## Memorandum Report

RE: Proposed Ashton Woods Development  
Groundwater concerns

Proposed infiltration pond

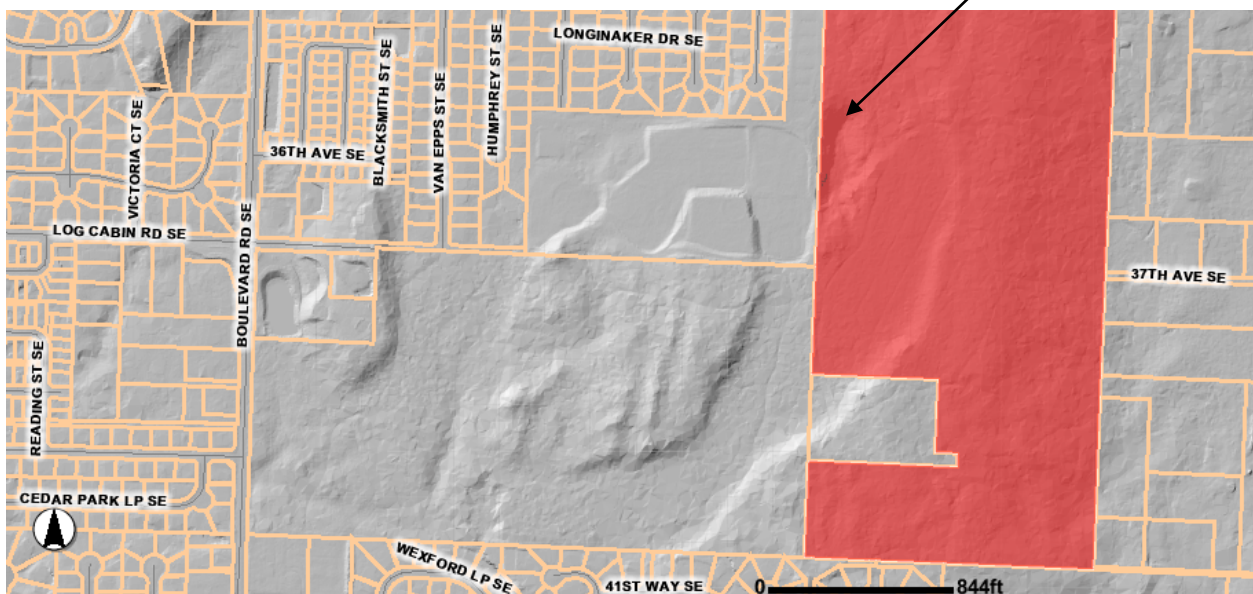
The proposed infiltration pond appears to be located in a relic channel, or paleochannel, of glacial drainage to the southwest through a portion of the Wilderness Development and towards Ward and Hewitt Lakes and the Deschutes River. The area to the southwest of the proposed infiltration pond is shown in a larger context in the following

The relatively constricted subsurface drainage due to this channel feature below the infiltration pit raises a concern for potential groundwater flooding and water quality impacts from stormwater discharge downgradient.

Proposed infiltration pond

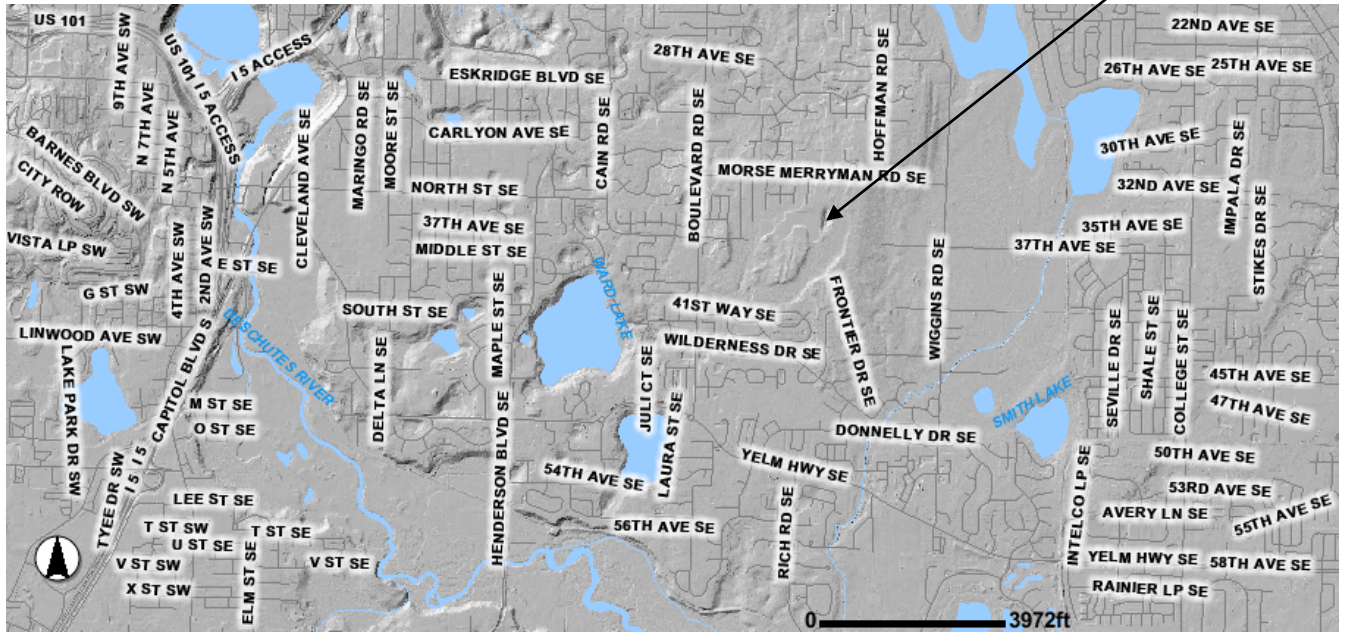
Both Ward Lake and Hewitt Lake are groundwater lakes and their water levels are the level of groundwater in the underlying aquifer.
